Special Bulletin

SP14-305A

Revision A: This document supersedes previous revisions.
Updated as per DA comments.

BI-FOLD DOOR - HINGE ARM ROD ENDS REPLACEMENT Prevost vehicles

FIGURE 4

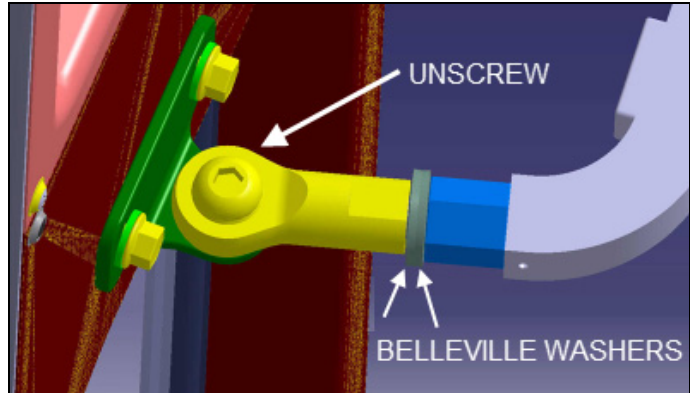
- 2) Remove the four hinge arm covers (2 screws per cover, figure 3).
- 3) While proceeding with one rod end at a time, unscrew and discard the bolt securing the rod end to the door panel attachment bracket (figure 4).
- 4) Keep the bi-fold door closed. Unscrew the existing rod end. **VERY IMPORTANT**, take note of the Belleville washers' position. All of the Belleville washers will have to be reinstalled with the concave sides against the other like this ().
- 5) Use Loctite 243 on hexagonal stud treads. Install a new rod end and tighten to a torque of 60 lbf-ft then loosen slightly until flat side is horizontal to allow fastening to the door attachment bracket.

FIGURE 6: FILL ROD END WITH FRESH GREASE THEN REPLACE GREASE FITTING WITH SCREW G5010160

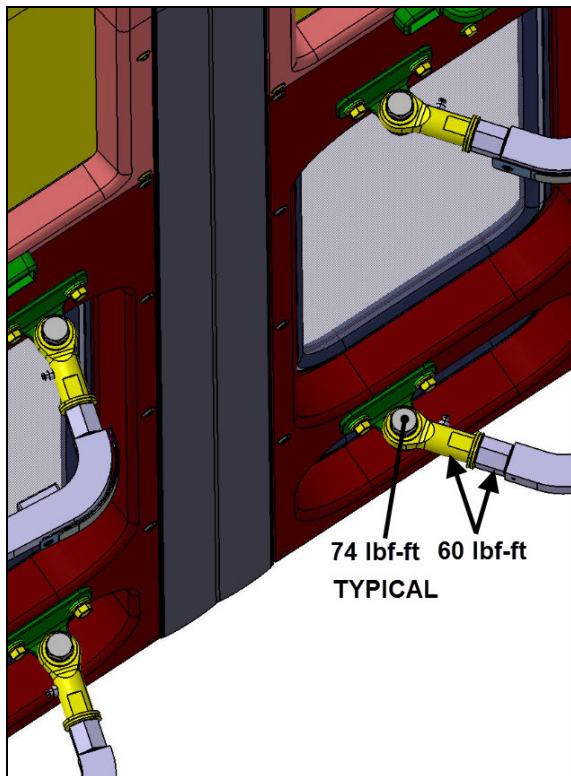
- 6) Fasten the rod end to the door attachment bracket using new bolt 502875, new split lock washer 500747 (against bolt head) and new flat washer 500958. Tighten to 74 lbf-ft, use Loctite 243 on threads.
- 7) Proceed similarly with the second rod end on the door panel and then to the second door panel.
- 8) Fill the rod ends with fresh grease and clean grease in excess. Remove the four grease fittings and replace with screws G5010160 (figure 6).
- 9) Reinstall the four hinge arm covers.
- 10) Turn the emergency release valve counterclockwise to normal position.
- 11) Operate the door several times to confirm proper operation.
